PEQUOT FARMS SUBDIVISION

STONINGTON, CONNECTICUT

REVIEW DATE: NOVEMBER 14, 1989

**ENVIRONMENTAL REVIEW TEAM REPORT
ON
PEQUOT FARMS SUBDIVISION
STONINGTON, CONNECTICUT**

SITE PLAN

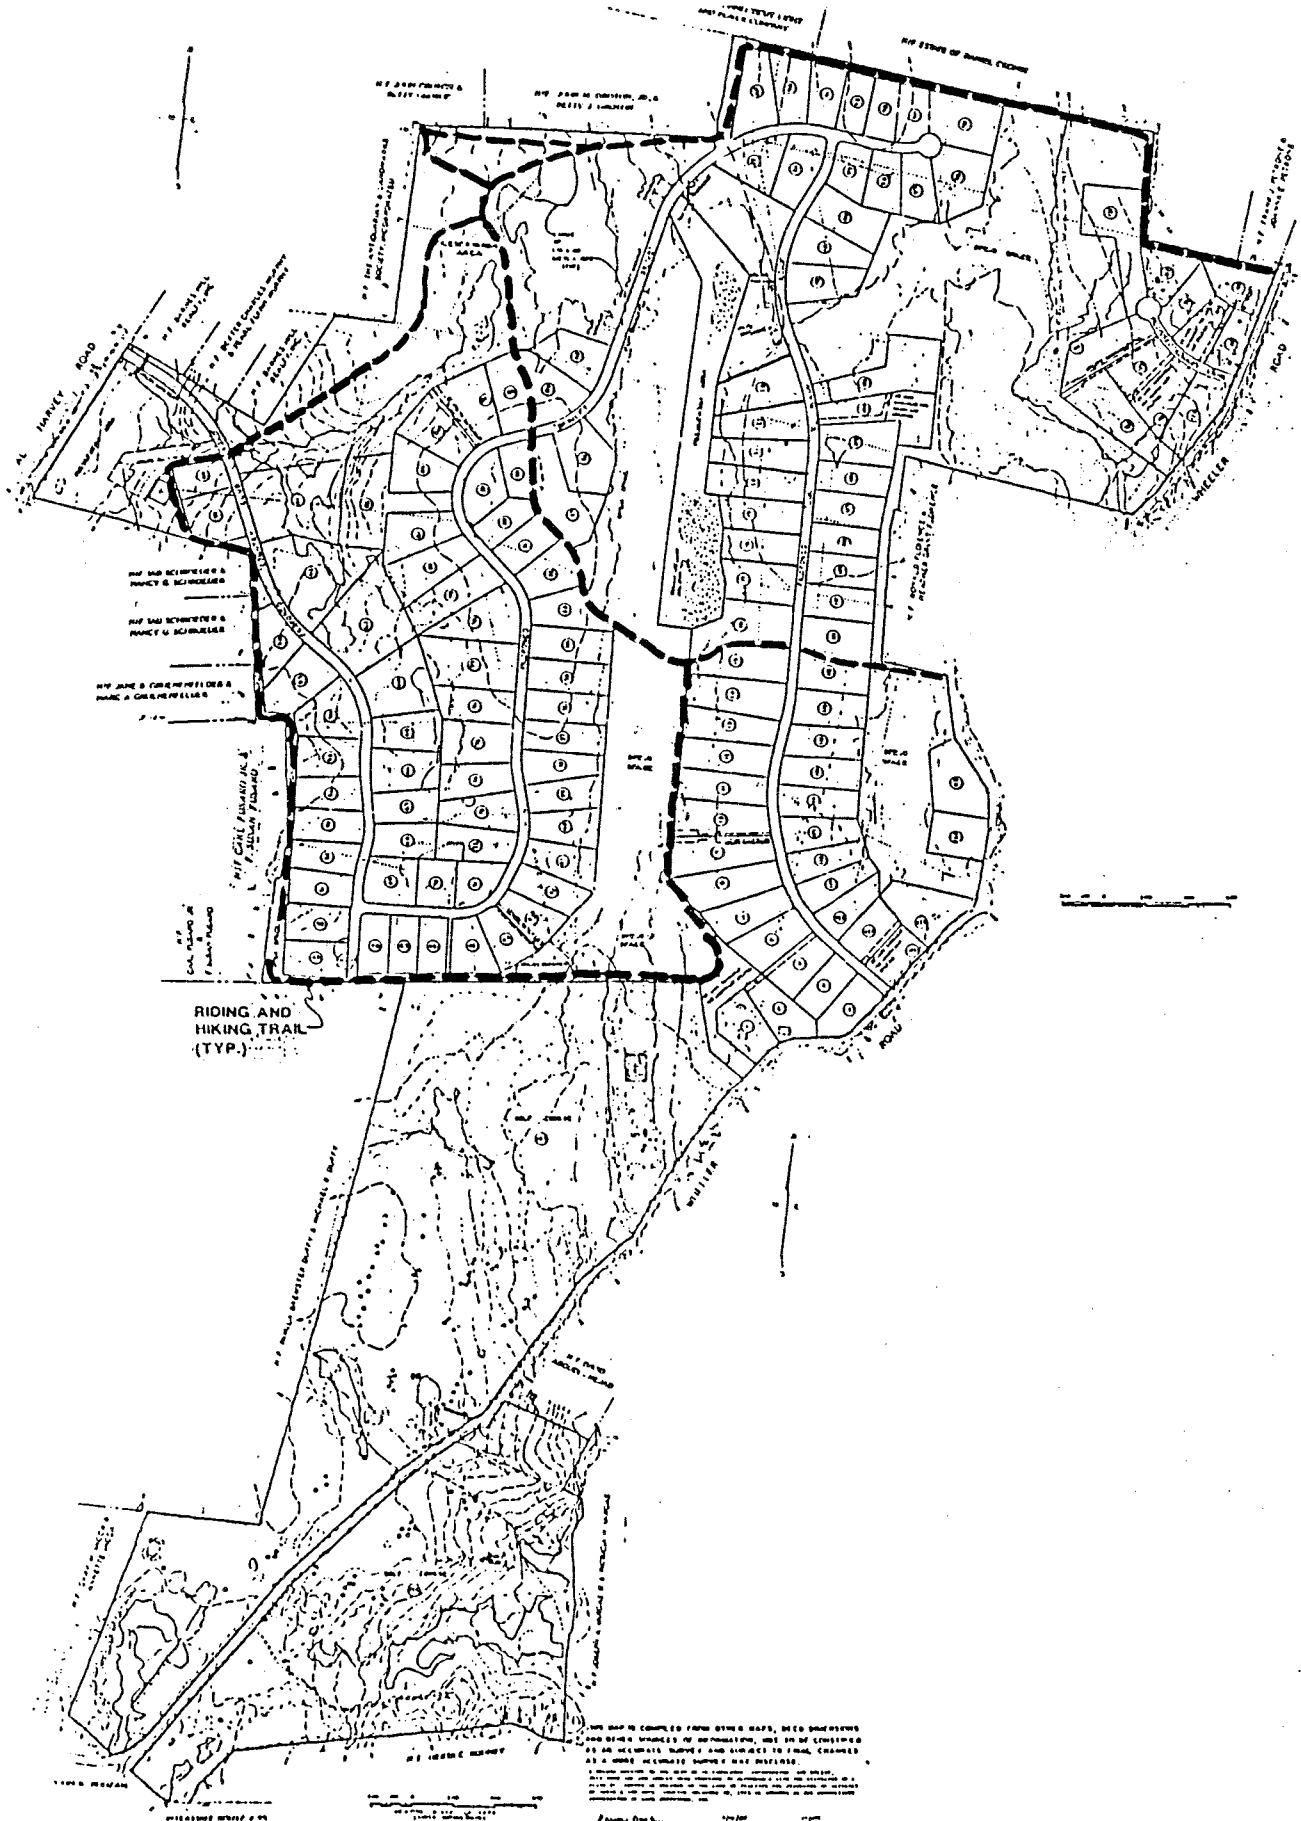
Access to the single-family development will be accomplished by a road that meanders through the site from Al Harvey Road to Wheeler Road. A cul-de-sac, serving lots 129-135 in the northeast corner will come in from Wheeler Road.

Based on the present road layout, the primary road will need to cross about 630 linear feet of (Rn) soils and their through flowing streams on the site. In addition, grading for roads may, in places, infringe on the regulated wetland soils.

Present plans indicate that increased peak flows following construction of the development will be controlled by the creation of three detention basins. These control structures will be created in the southern, western and northcentral parts of the site. The latter detention area will be located in a regulated wetland and therefore requires a permit from the local inland wetlands commission. The remaining two

Crossing #1. According to the site plan dated June 1989, access to the site from Al Harvey Road is proposed to be accomplished by crossing a band of wetlands approximately 90 feet wide. In this vicinity, however, a large area of surface ponding has occurred as a result of the creation of a berm structure downstream. Crossing this ponded area will entail a great deal more impact than the crossing presently depicted on the site plan. Regardless of how the pond originated, it is now a regulated area. If the berm is in the applicant's property, then the wetland's commission may require that the applicant remove the berm to restore the natural drainage patterns. This would decrease the degree of surface ponding and decrease the complexity of the crossing at this location. If the commission opts to require the applicant to remove the berm, then it should be made a condition of the permit. If a crossing is approved at this location, the Guidelines for Soil Erosion and Sediment Control should be strictly enforced and Best Management Practices should be employed.

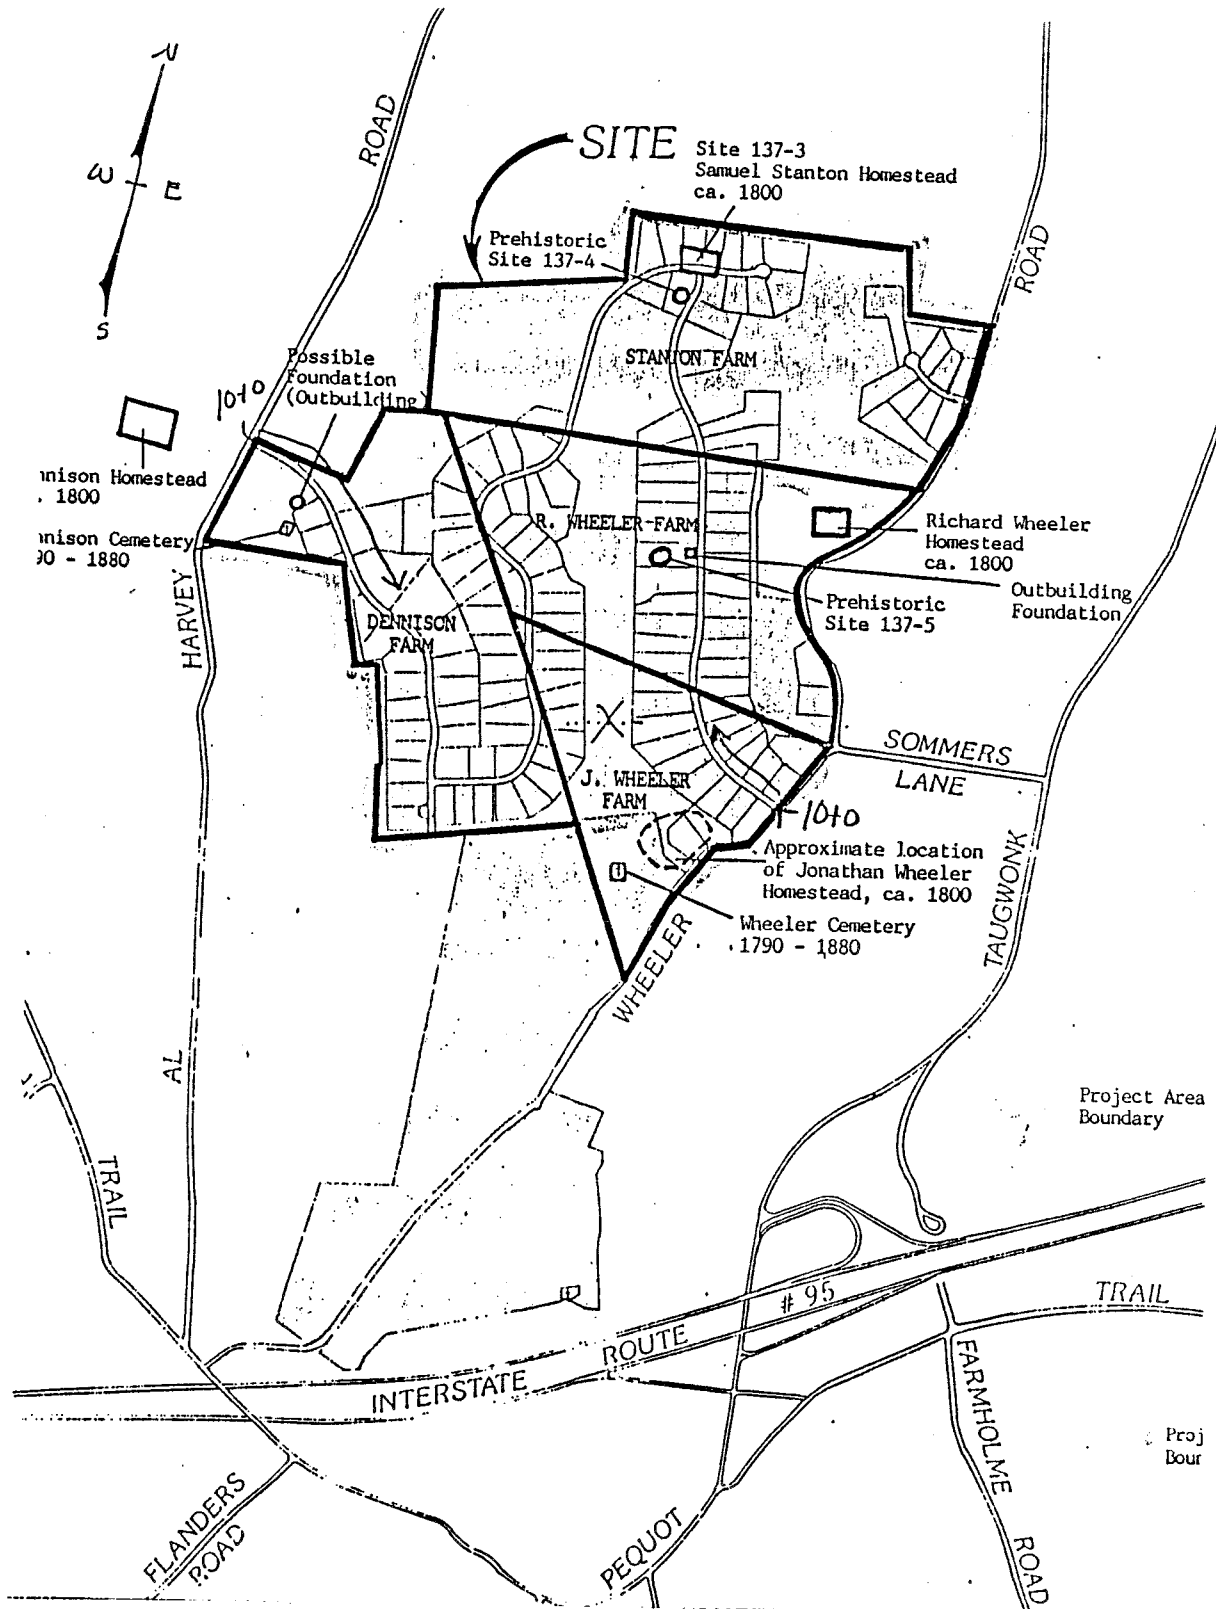
Two prehistoric sites (137-4 and 137-5 on map) were found in the project area. Each of these sites yielded limited, undatable cultural material, even though additional test pits were excavated in their vicinity. Neither site is likely to yield additional data.

Based upon the potential impacts to the Thomas Stanton farmstead (Site 137-3) from potential road construction, it is recommended that further intensive surveys be conducted to identify more precisely the site limits and to assess the site's potential for inclusion in the National Register of Historic Places. If the site demonstrates eligibility for the Register and the road cannot be redesigned to avoid impacting a portion of the

site, it is further recommended mitigation of impacts through archaeological excavation and documentation of that portion of the site that will be impacted by the proposed road construction and preservation of those portions of the site that have the most potential for yielding information in the future. Steps should be taken to avoid as much of the site as possible during construction and to develop a long-term preservation plan for the site.
